October 12, 2016

MODENA STREET (HARRISON TO SPRING) SIDEWALK

Addendum #1

SHEET X-5

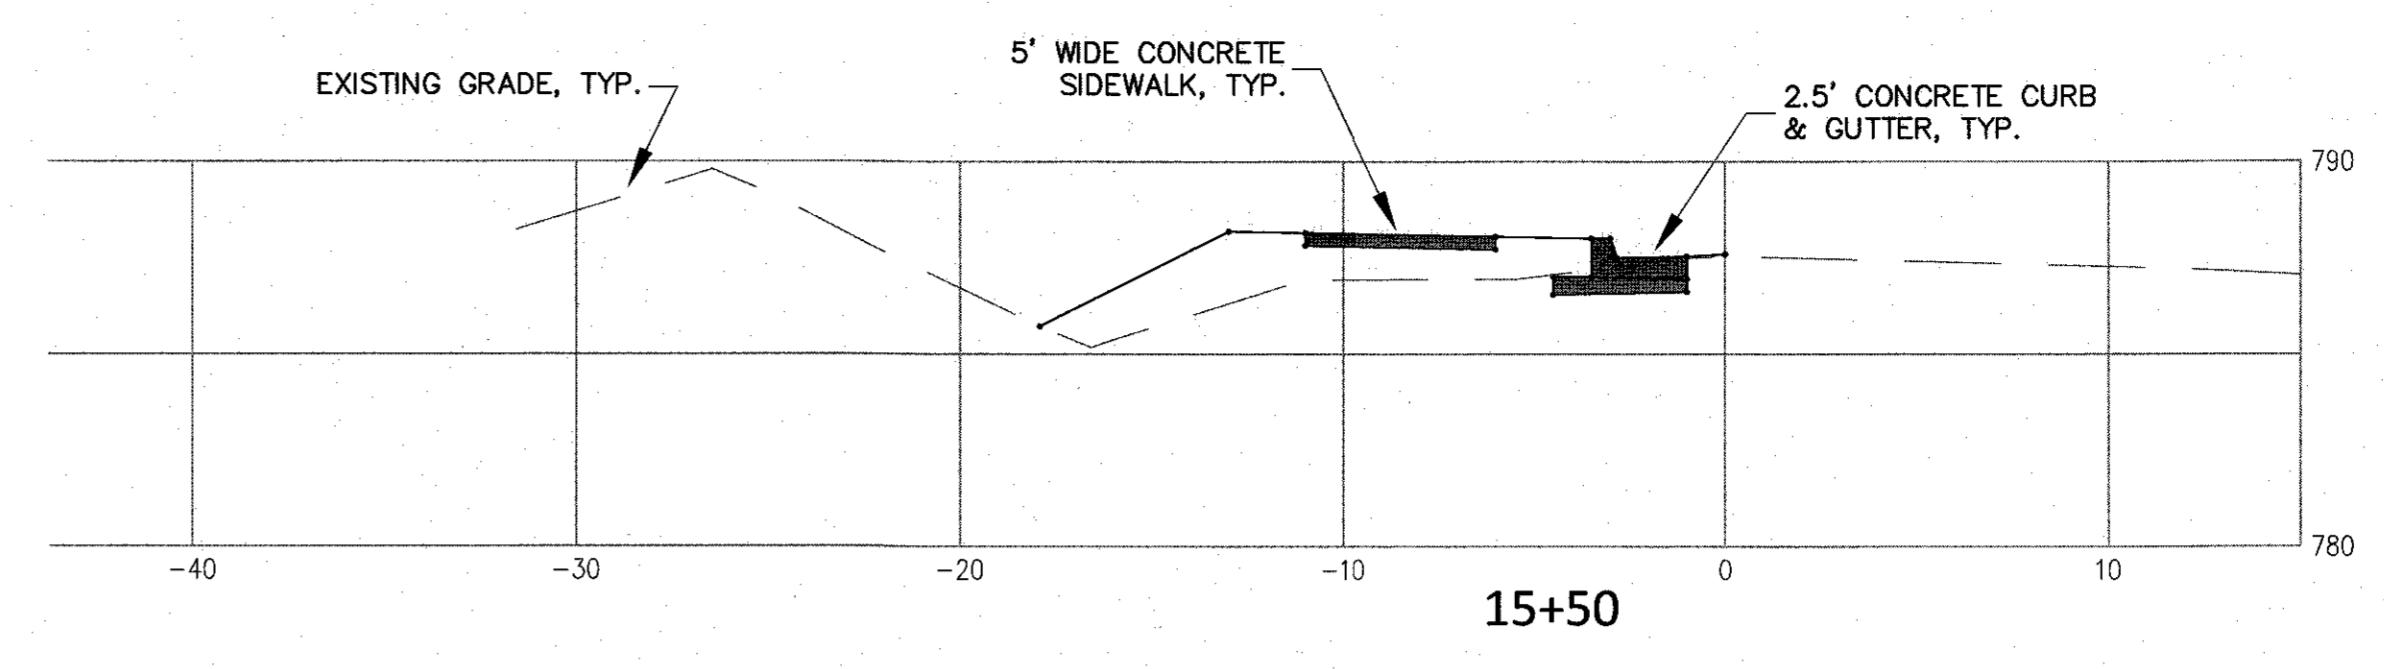
- Additional cross sections for proposed sidewalk from Sta. 0+00 to 9+00 and 13+50 to 16+09. (X-1 thru X-5) are attached to this Addendum. If you have already picked up your bid documents and plans, and would prefer a hard copy of the revised sheets, please contact caryr@cityofgastonia.com.
